*MEMORANDUM*

TO: Electronics  
FROM: Daniel Sigg  
SUBJECT: Modifications to the ISS second loop servo  
Refer to: LIGO- E2100162-v1

This modifications are applied to the "Outer Loop ISS Chassis," [D1600229](#), which includes version 3 of the "ISS Outer Loop Back Board," [D1600298](#), and version 3 of the "Outer Loop ISS Transimpedance Board," [D1600193](#).

OuterLoopBackBdv3 (11-29-2017 2-36-39 PM)

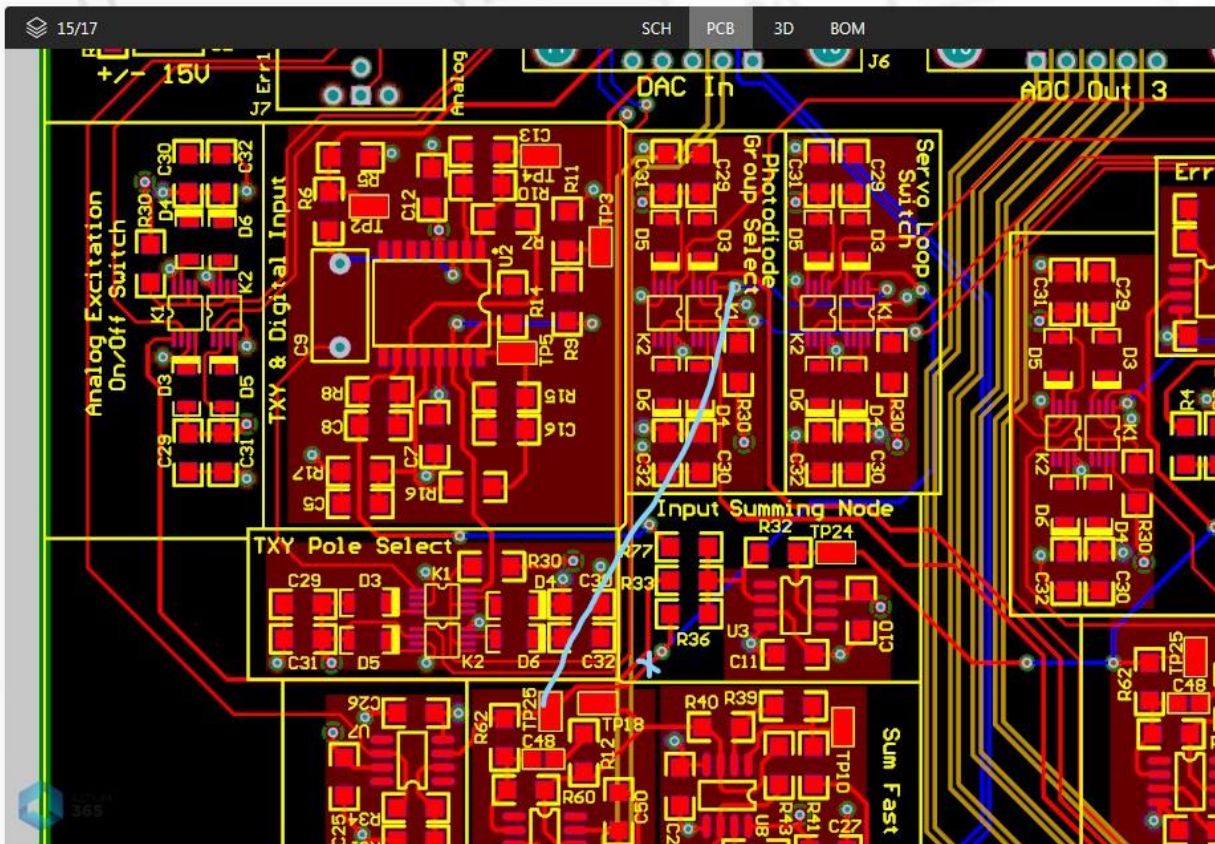
Connect feedback of the open Op Amp U2B to the negative input and ground the positive input.

Increase the gain of the sum by increasing R32 to 10K (from 1K).

Swapped the corresponding OpAmp U3 from OP27 to OP37 (faster).

Decrease the gain in the readback of ERR2 after the sum by 10 by changing R62 in the SUM signal block from 4.53K to 45.3K.

Decreased the analog excitation input gain by 10 by increasing R33 to 100K from 10K.

Decreased the digital excitation input gain by 10 by increasing R77 to 100K from 10K.

Change the ISS second loop error point readback, ERR1, to before the servo loop switch. Cut the top trace between TP25 (Sum Fast PE) and R36 (input summing node) below the via, and add a jumper between TP25 and the via next to pin 1 of K1 (photodiode group select)

U2B → connect output to -input, ground +input

R32 → 10 kΩ

U3 → OP37

R62 → 45.3 kΩ

R33 → 100 kΩ

R77 → 100 k $\Omega$
